REMARKS

Appl. No.: 10/616,645
Response to Office communication dated: 2/6/2004
Attorney Docket: HKPC/363/US

Figure 3

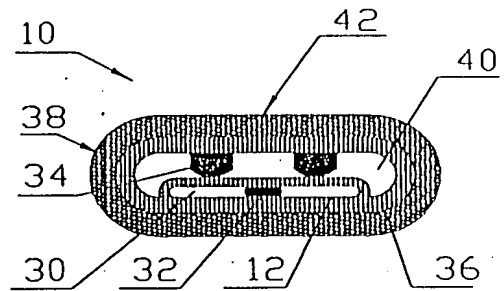
The Office Communication objected to the drawings under 35 C.F.R. 1.83(a). More particularly, the objection asserted that the underwire was not shown in the figures. Applicants point to, for example, Figure 3, element 32 as one place in the figures where the underwire is shown.

Figure 4

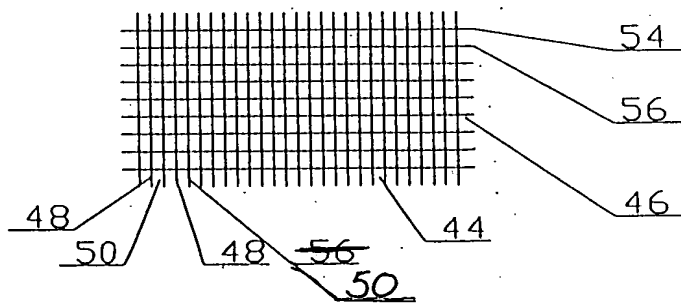
The Office Communication indicated that it was not clear as to whether the depiction of the two pieces of elastic nylon thread and two pieces of fusible thread in alternating are shown in the drawings. Figure 4 has been amended more clearly indicates this feature.

Claim 6 was rejected because it was not clear as to whether the specification provides support for the warp threads being comprised of two pieces of elastic nylon thread and two pieces of heat fusible thread in alternating order. This feature is supported by the specification at page 5, lines 15-22 and by amended Figure 4. Claim 6 is in condition to overcome this rejection.
